Re: St. Lucie Plant Unit 1  
Docket No. 50-335  
Renewed Facility Operating License No. DPR-67

Response to NRC Instrumentation & Controls Branch Request for Additional Information Regarding Extended Power Uprate License Amendment Request

## **Response to Request for Additional Information**

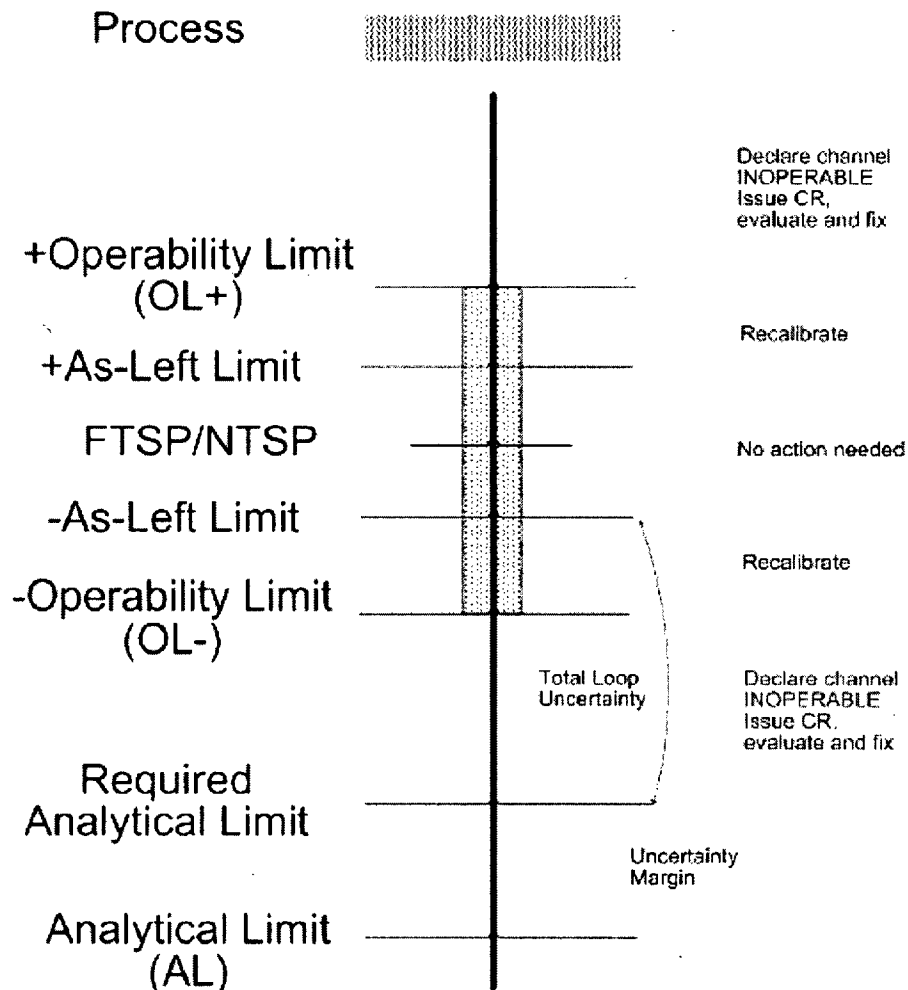
The summary of the calculation provided does not contain all the information needed by Staff to complete the review. The licensee is requested to provide the Staff with a copy of the calculation since this is the only calculation that involves setpoint change. The calculation should clearly state the as-found tolerance, as-left tolerance, the allowable value and the NTSP or the FTSP.

The requested Steam Generator Level setpoint calculation is identified as CN-TAS-08-36, Revision 1, "Setpoint Uncertainties and Operability Limits for the Steam Generator Level RPS and AFAS Functions for St. Lucie Unit 1". This calculation is a Westinghouse proprietary document and will be made available for NRC review. As documented in the Technical Specification markups of Attachment 3 of the EPU License Amendment Request (NRC Accession Number ML103560427), the proposed RPS Low Steam Generator Level TS trip setpoint is  $\geq 35.0\%$  and the Allowable Value is  $34.78\%$ , which is equal to the low side of the Operability Limit band. OL limits (synonymous with AFT), as-left tolerance and FTSP are defined in the setpoint calculation and illustrated in the following figure that has been extracted from the setpoint calculation.
